GUAM WATERWORKS AUTHORITY

Design-Build of GWA Upper Tumon Warehouse Renovation GWA Project No. 42102, IFB-01-ENG-2025 GWA Response to Request For Information (RFI) No. 1

IMAGE 1

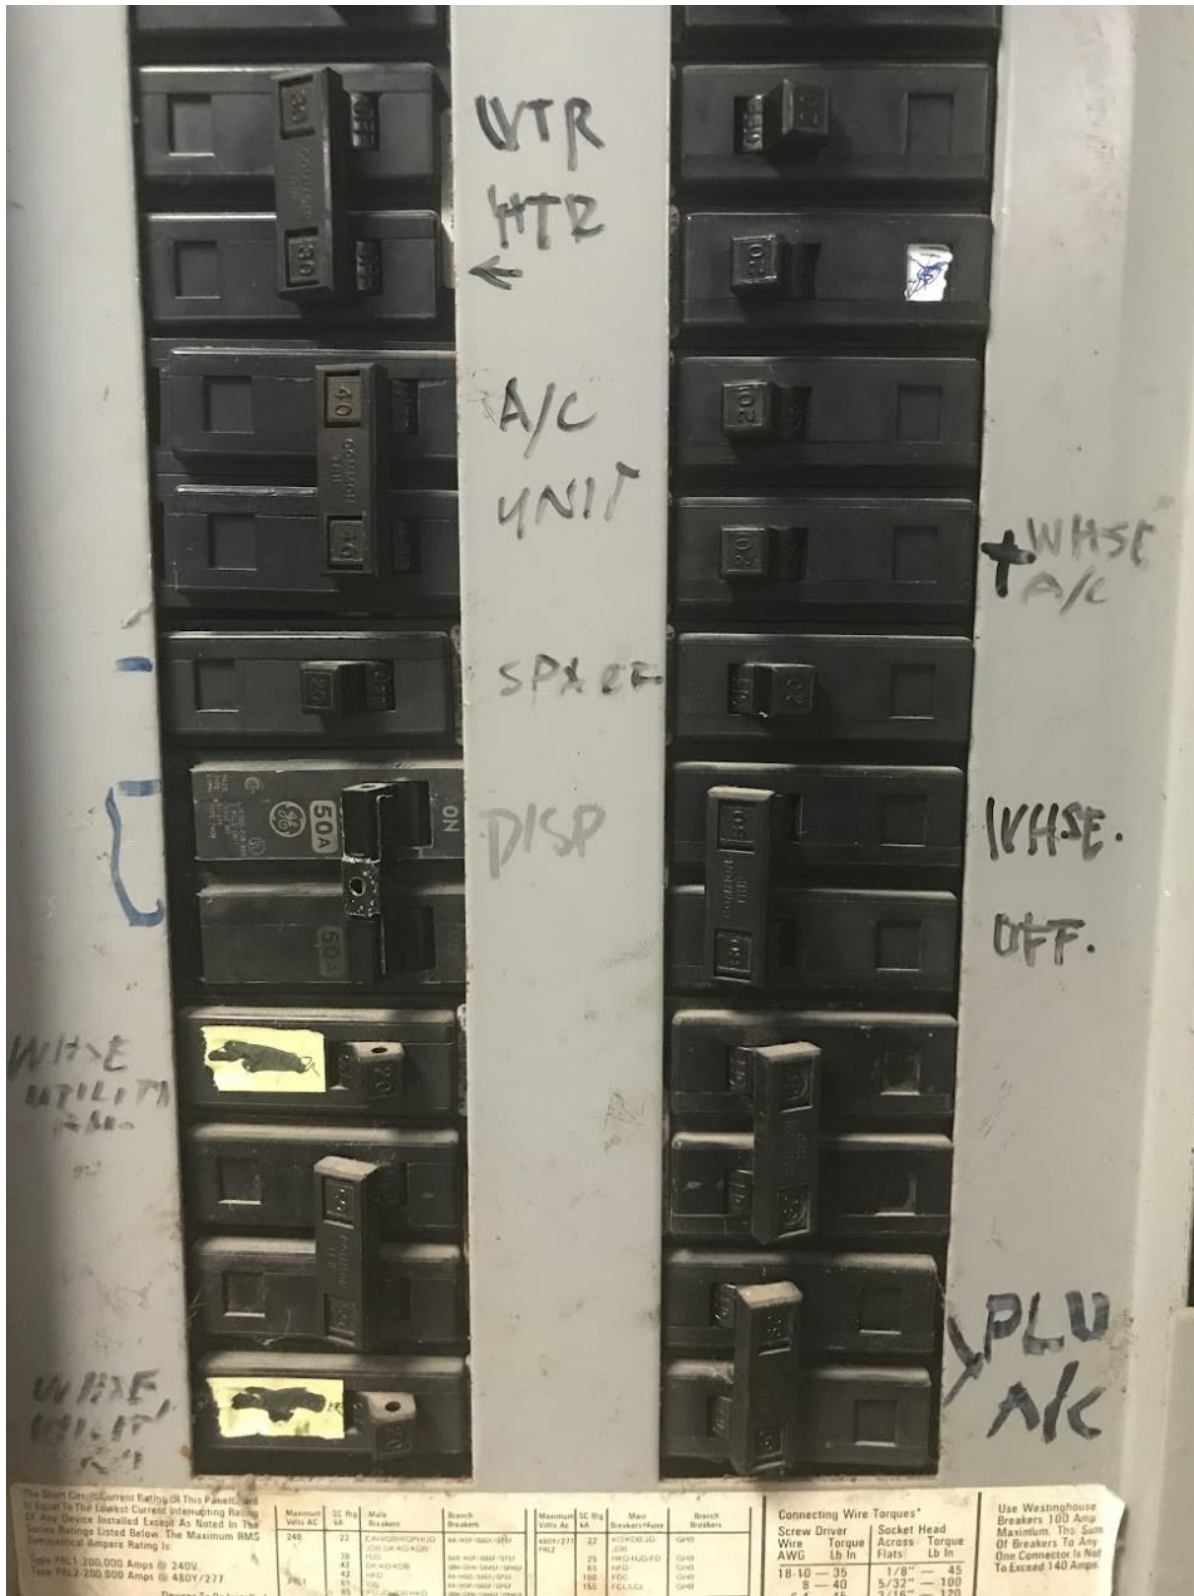
25	1/24/2025	Would the existing electrical panel be retained? Kindly provide the panel schedule of the existing panel.	<i>There are four panels: a 400A panel, a 200A panel, a 150A panel, and a 125A panel. The 400A panel provides power to the 200A, 150A, and 125A panels. Demolish and replace all four panels. For the 200A panel, please see Image 1 for the panel schedule and Image 2 for markings on the panel itself. For the 150A panel, please see Image 3 for the breakers in the panel.</i>

EXHIBIT 'A'

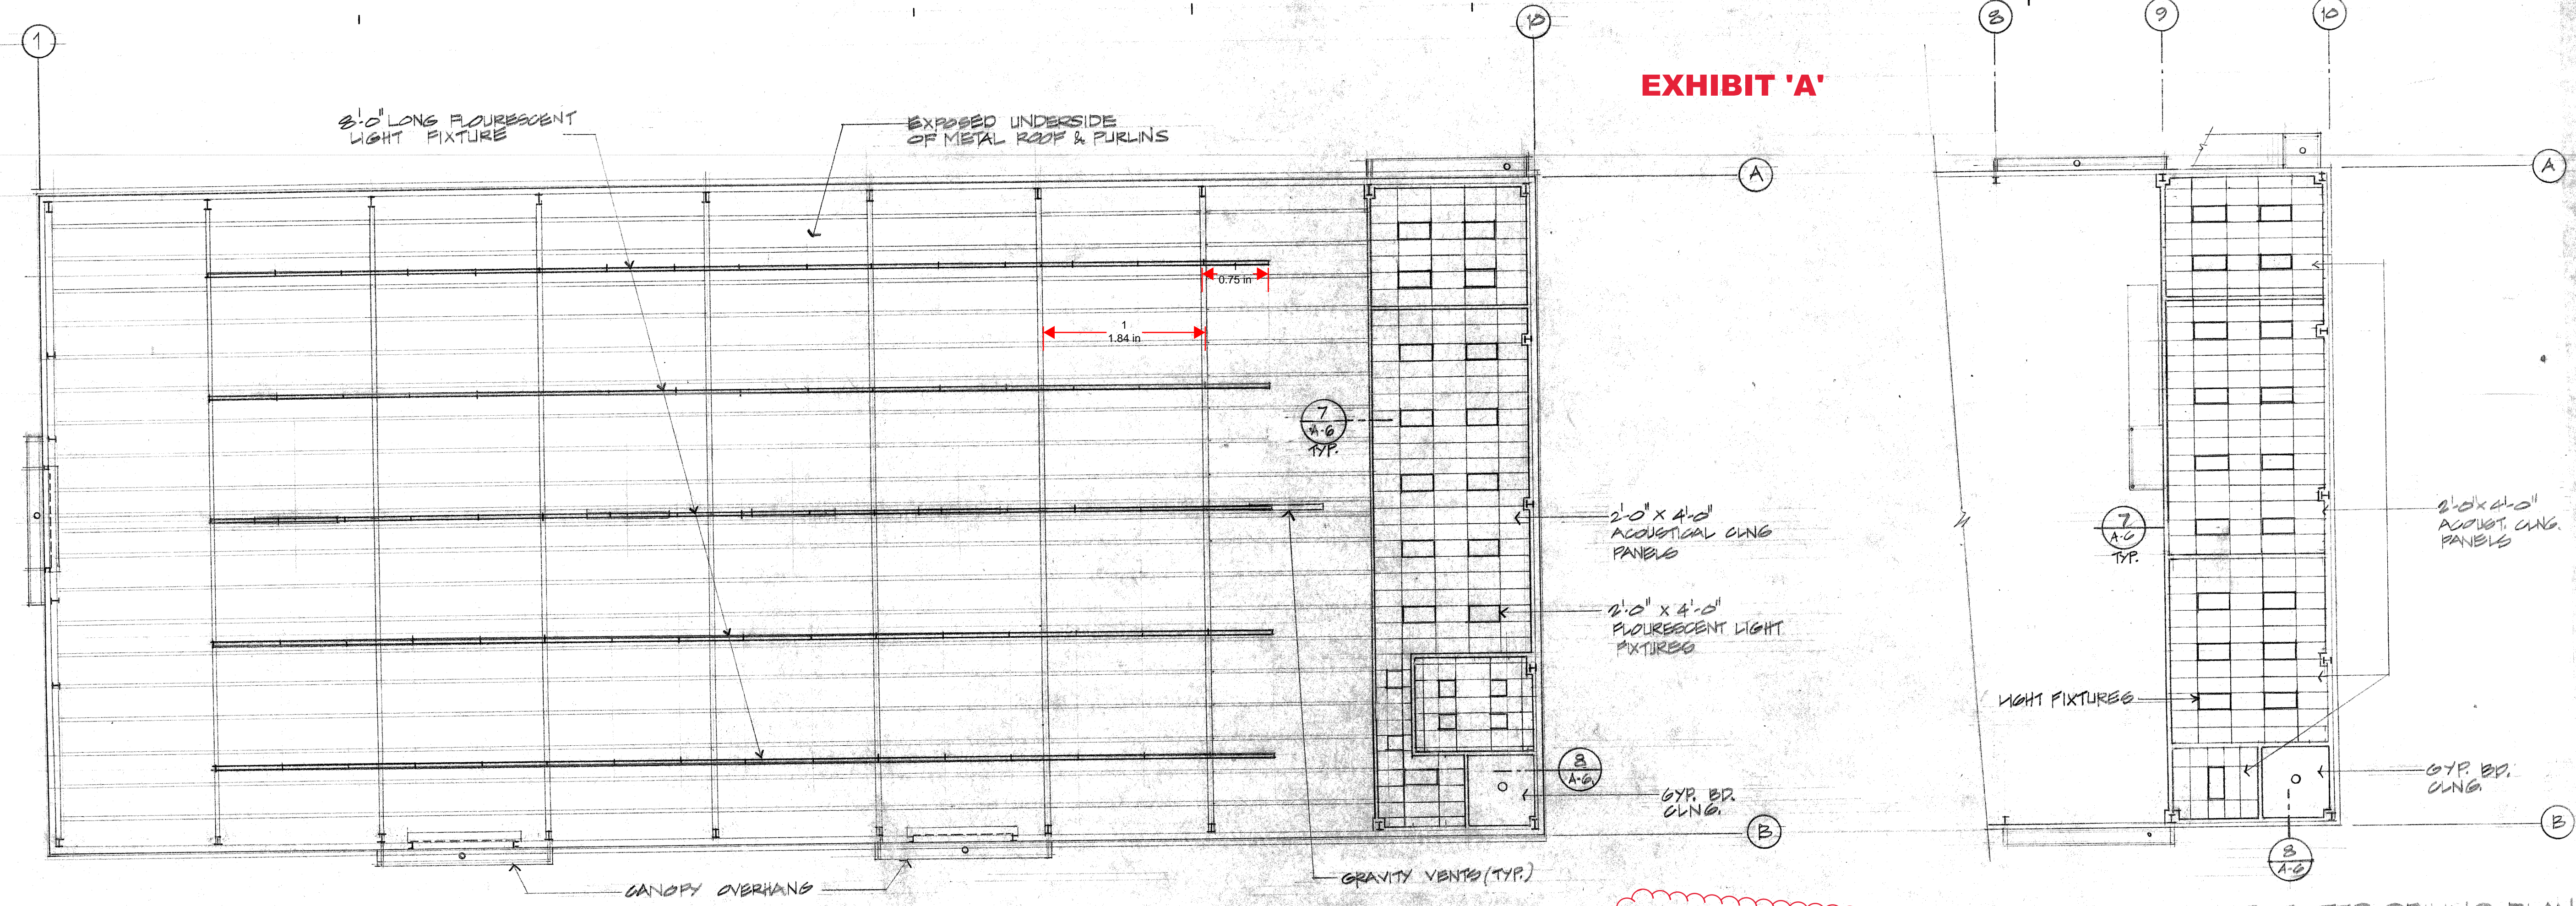
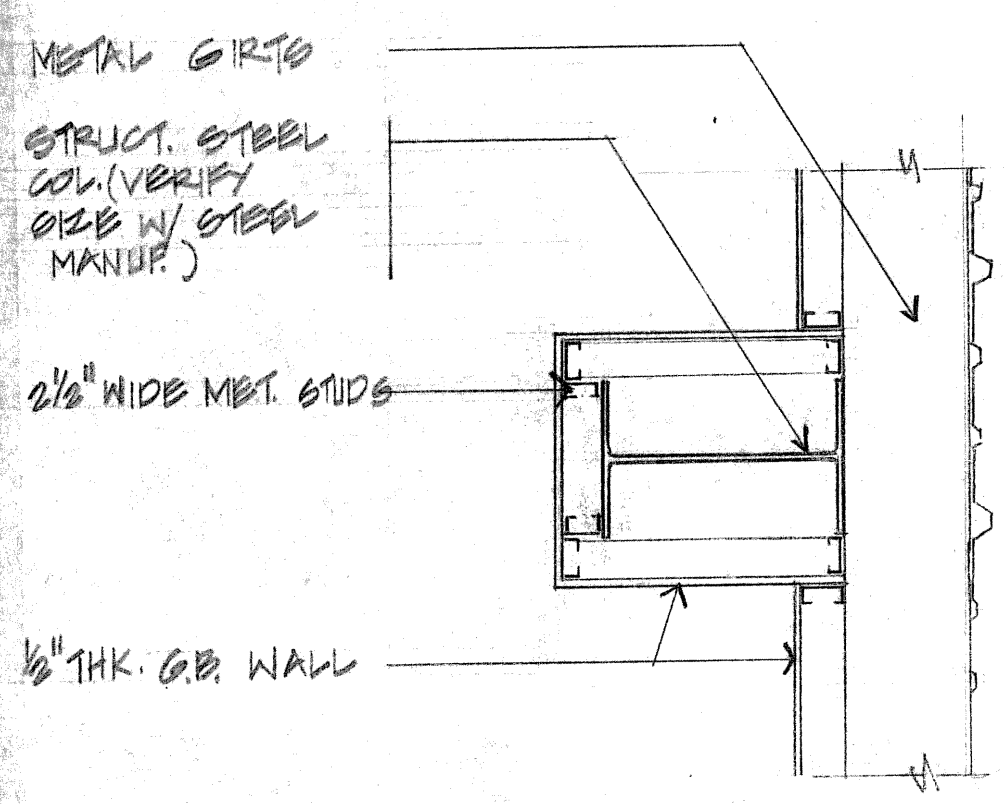
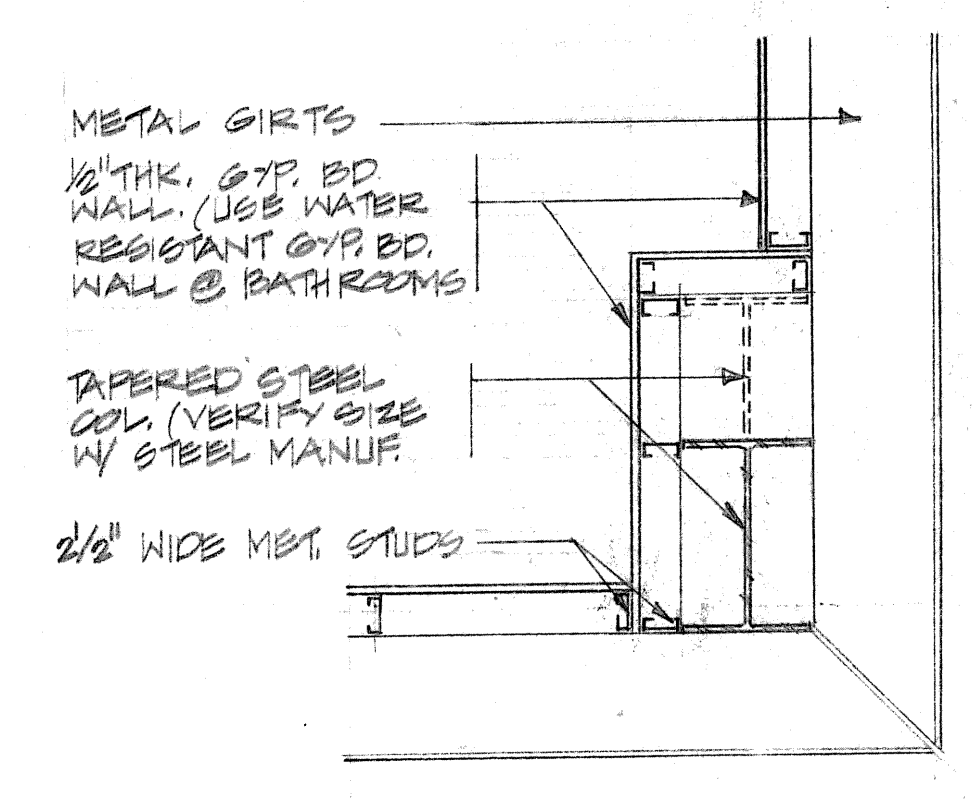
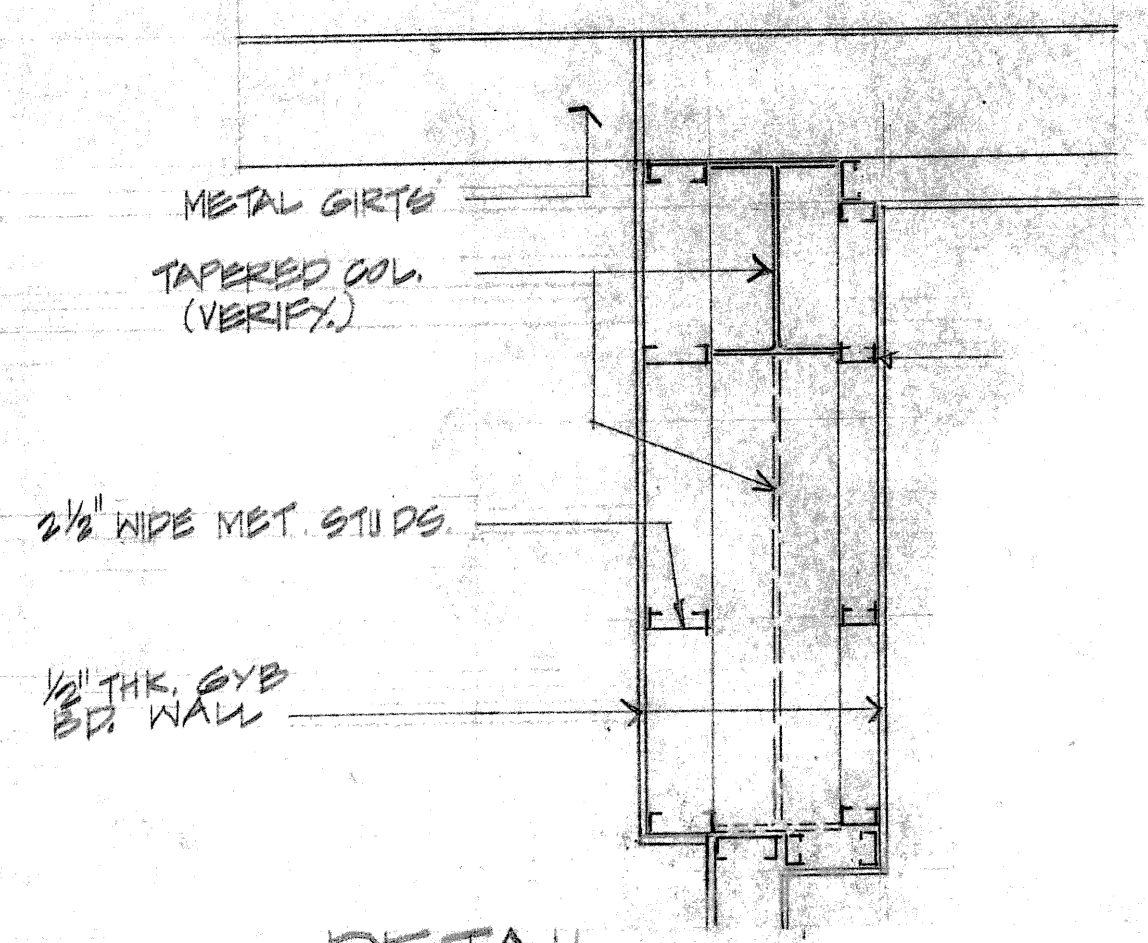
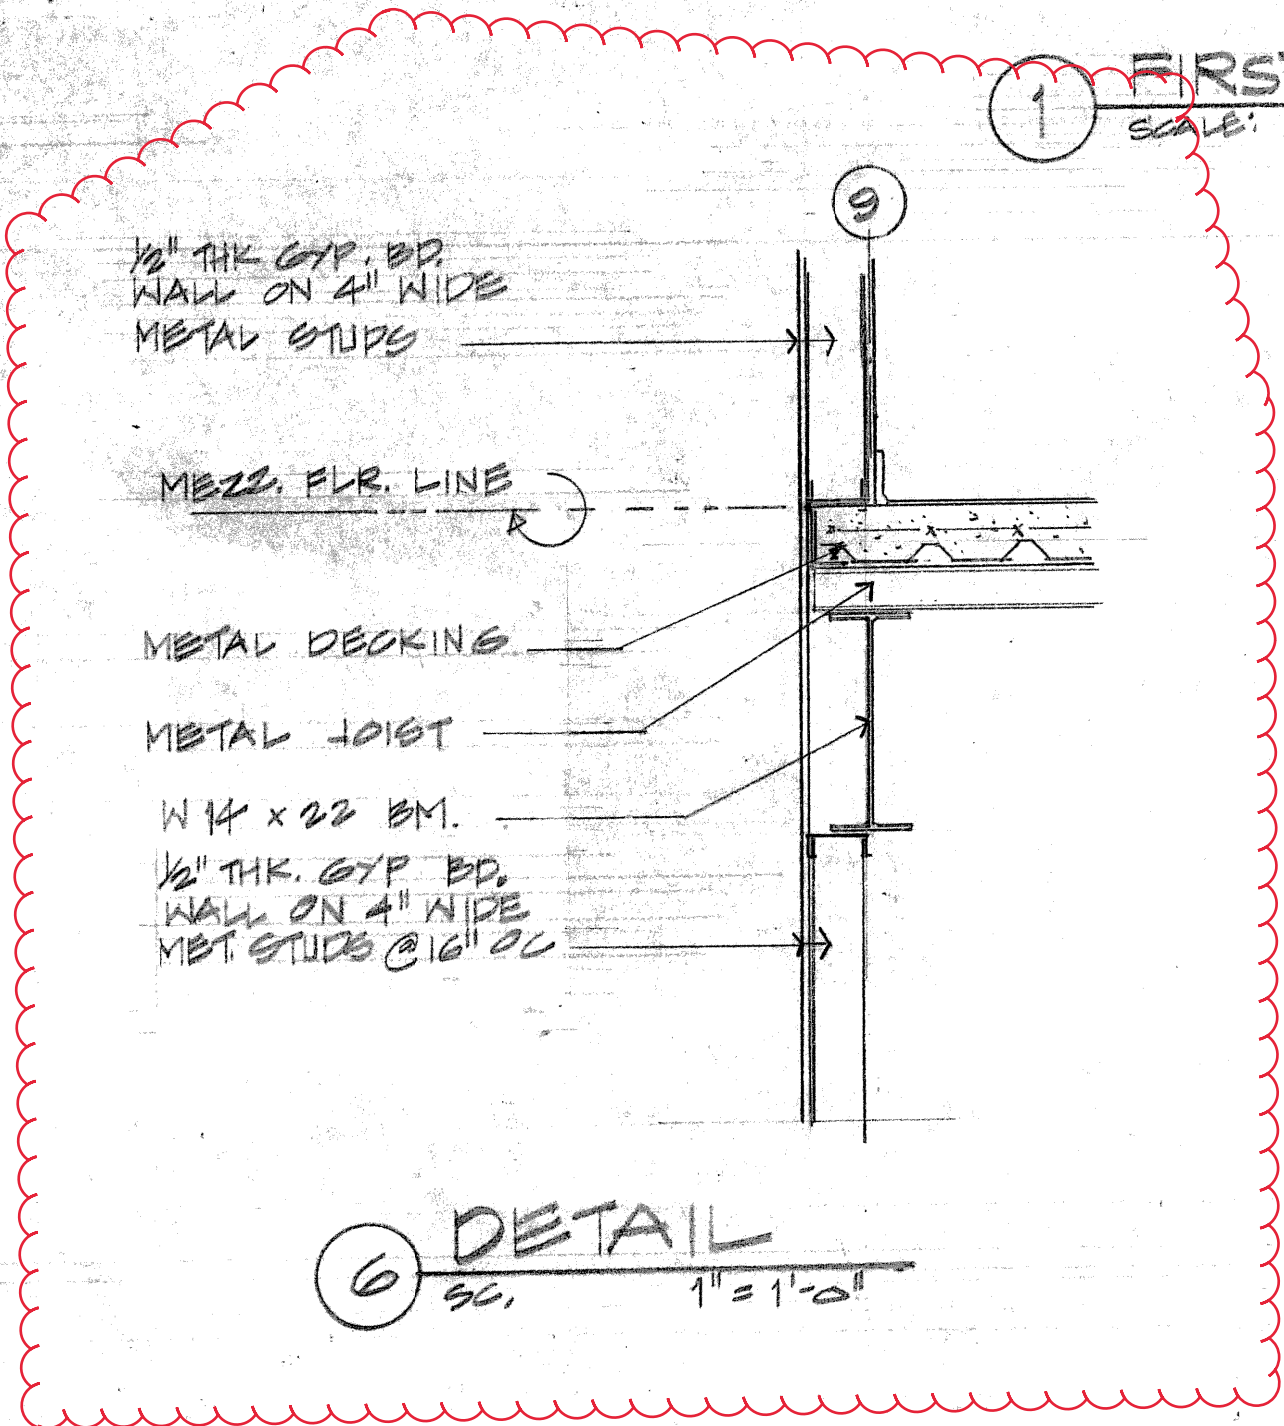
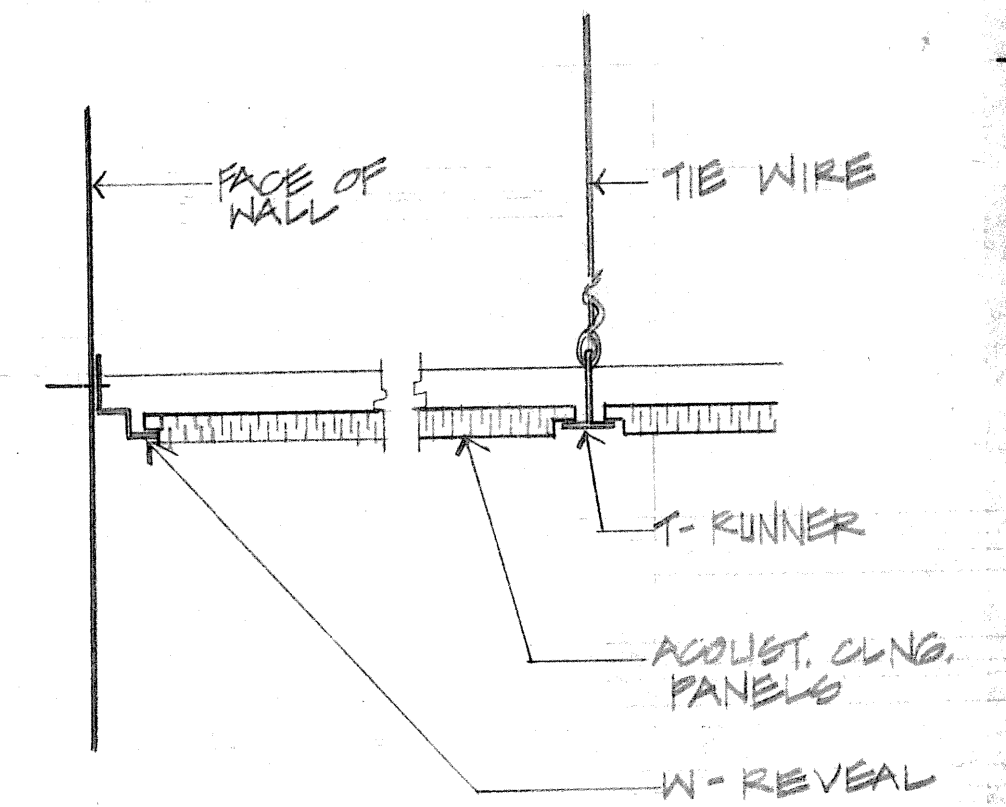
17	1/21/2025	Mezzanine vinyl flooring is to be removed and replaced with tile flooring. Please describe the existing flooring assembly for the design team to evaluate if the floor can accept the additional loading and that it will accept tile and not crack.	<i>Refer Exhibit “A” of the Attachments.</i>
